**April 7, 2023**

Version 2

## Buzzing or Whining When Adjusting Power Front Seat Forward and Backward

Supersedes 19-024, dated November 12, 2019, to revise the information highlighted in **yellow**.

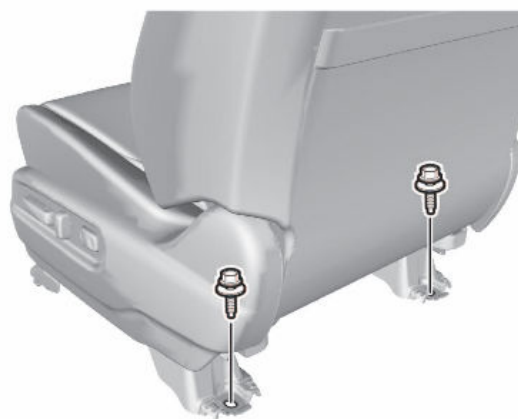
1. Remove the seat track end covers to expose the seat mounting bolts.

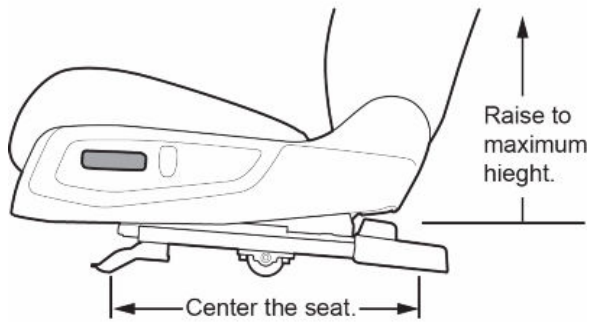
2. Remove the four seat mounting bolts.

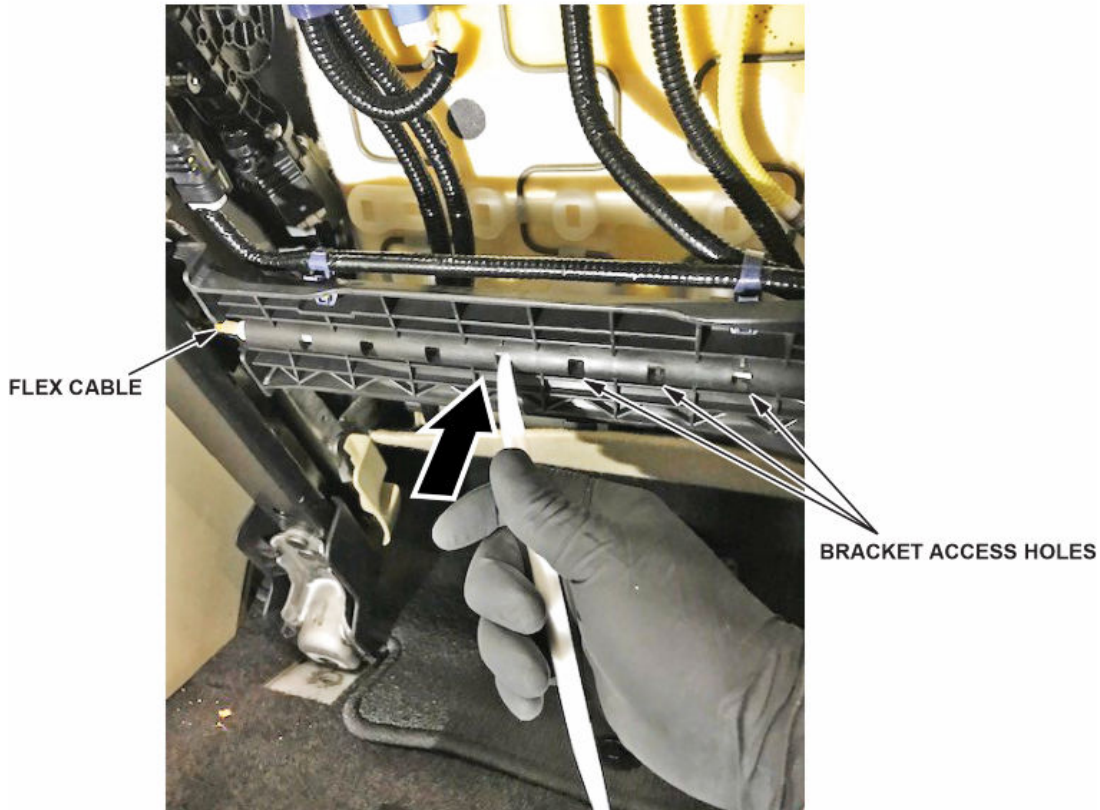
6. Tilt back the entire seat and disconnect the seat harness.

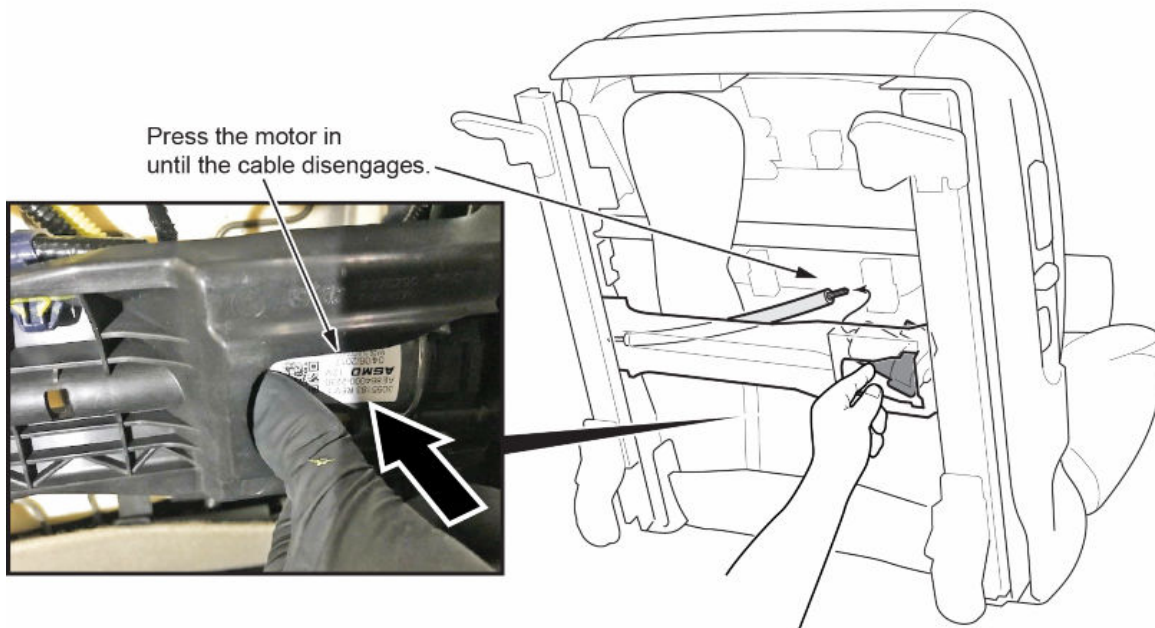
7. Insert a plastic trim tool or flathead screwdriver through the bracket access holes one at a time until the cable is released from the bracket.

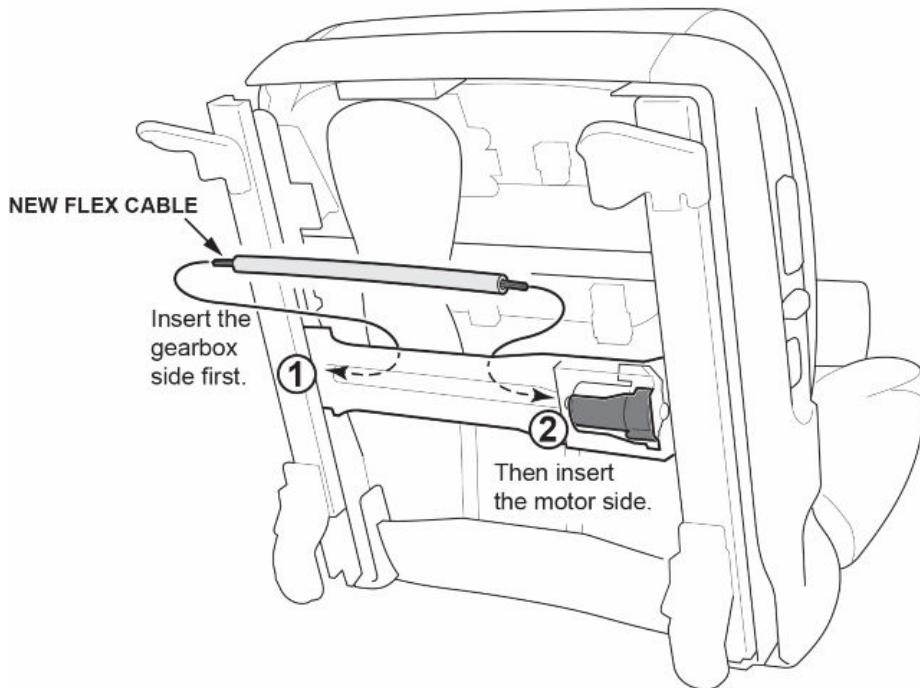
10. Install the new flex cable in the reverse order of removal. Start by inserting the cable into the seat rail gearbox side, then fully insert the other end into the motor.

NOTE: Make sure to not bend or kink the cable during installation.

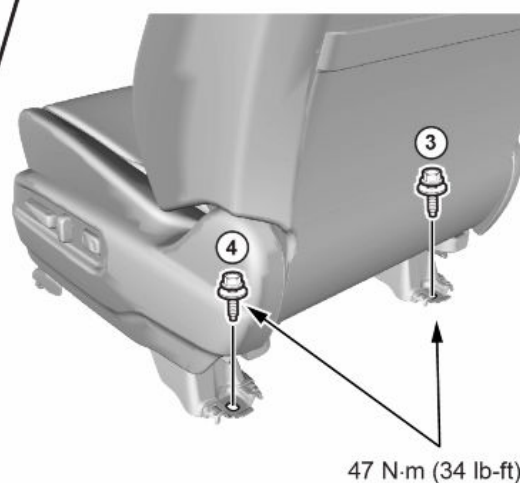
11. Snap the cable end of the motor back in to its mounting bracket, and make sure the flex cable is fully inserted and horizontal.
12. Center the flexible plastic tube on the flex cable.
13. Snap the flex cable assembly back into the plastic bracket, and make sure it is straight. If the cable is not straight and flat it will make noise when the seat is adjusted.
14. Connect the seat harness and harness clip.
15. Connect the 12-volt battery.
16. Install the seat, then hand tighten the bolts.
17. Torque the bolts to specification as shown.
